ANNEXURE D

INFRASTRUCTURE REPORT & RFI RESPONSE

Hornby Quadrant • Shands Road, Christchurch

PCXX – Marsh's Road Industrial Extension

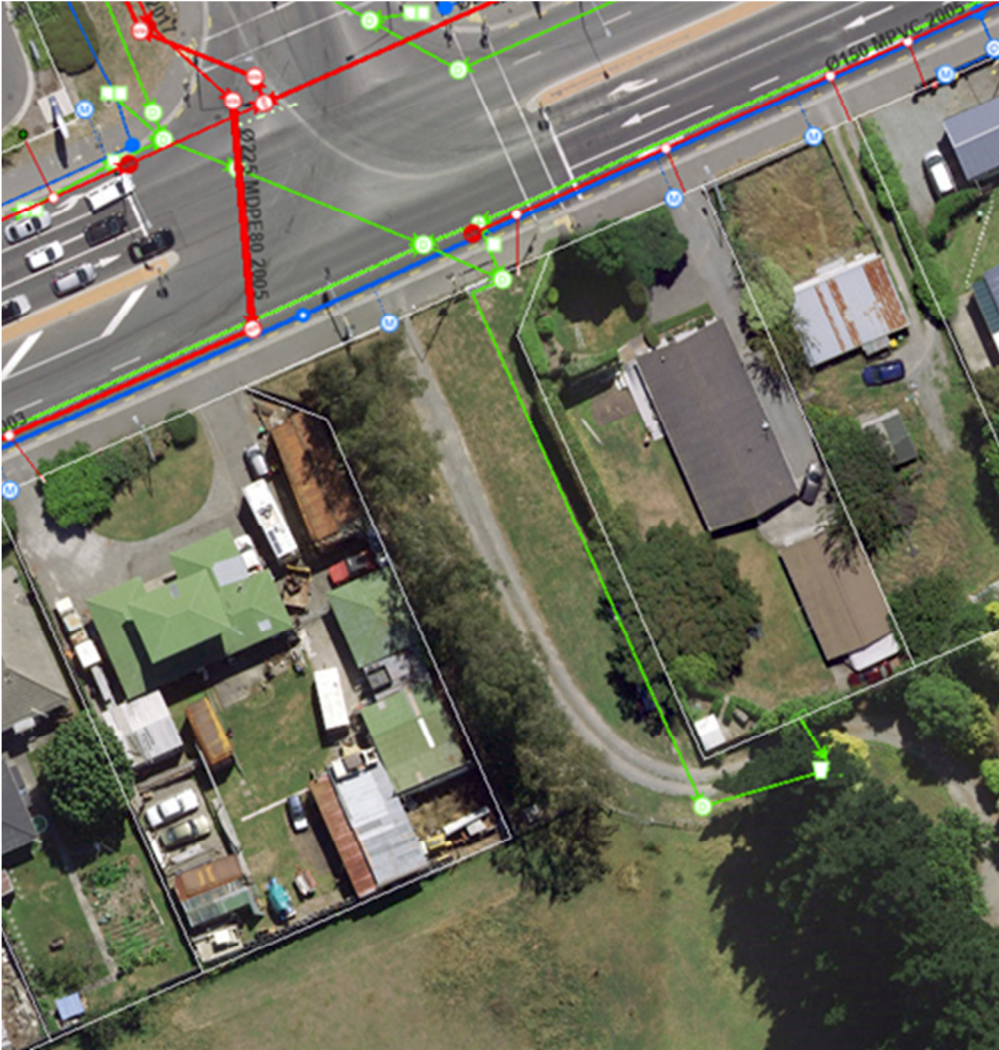
We have received the attached RFI for the Plan Change 19 Application.
Please refer to Item 8 in the attached document.
Plan of the ODP also attached

I was expecting to undertake the stormwater disposal on this plan change area under the CCC Global rather than consult with ECan.
